#### 4.2.1. Heterogeneity and Model Discretization

### *4.3. Chemical Retardation*

#### 4.5. Direct Release Through Human Intrusion

Fig. 5. Tensile failed volume from GASOUT predictions for various waste strengths and waste permeabilities.

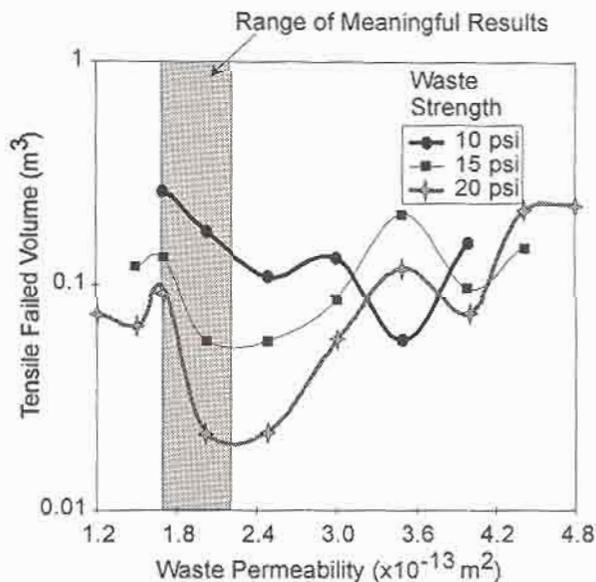
it is unknown which model's prediction is closer to reality. Testing of the new model<sup>(8,9)</sup> revealed serious instability problems outside a narrow range of waste permeabilities as shown in Fig. 5. For the waste strengths investigated there can be no confidence in waste permeabilities outside the narrow range of 1.7 to  $2.0 \times 10^{-13} \text{ m}^2$ .
